ONTARIO ENERGY BOARD

OEB STAFF SUBMISSION

FIVE NATIONS ENERGY INC.

EB-2016-0231

Chart 1 – Head Office Comparison (\$ / Sq. Ft.)

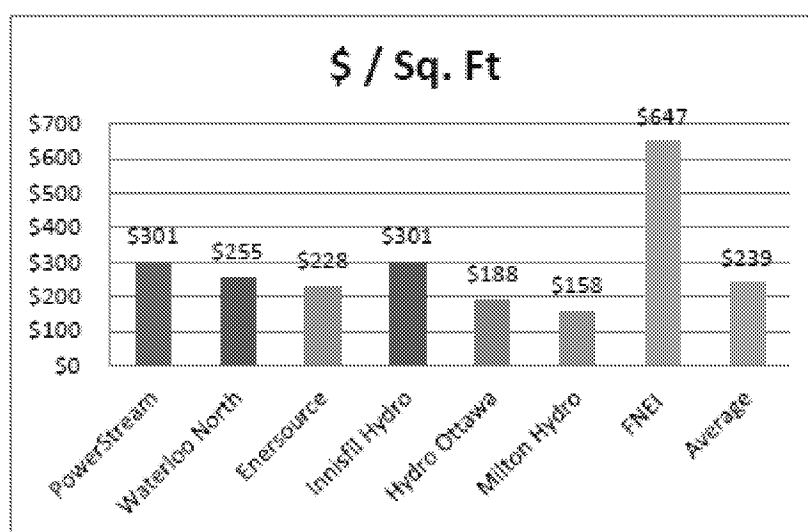
OEB staff will focus on the cost per Sq. Ft. metric as it is the most relevant metric for determining the premium that was likely incurred with respect to constructing FNEI's head office. FNEI's building cost was \$647 / Sq. Ft., which is \$408 more expensive than the average and \$346 / Sq. Ft. above the highest cost comparator.

OEB staff acknowledges that this is a significant reduction. However, OEB staff submits that minimal harm to FNEI will arise from a finding to remove \$2.08 million from rate base for the following reason.

For all of the above reasons, OEB staff submits that it is appropriate to remove \$2.08 million from rate base to reflect FNEI's imprudent spending on its Timmins head office.
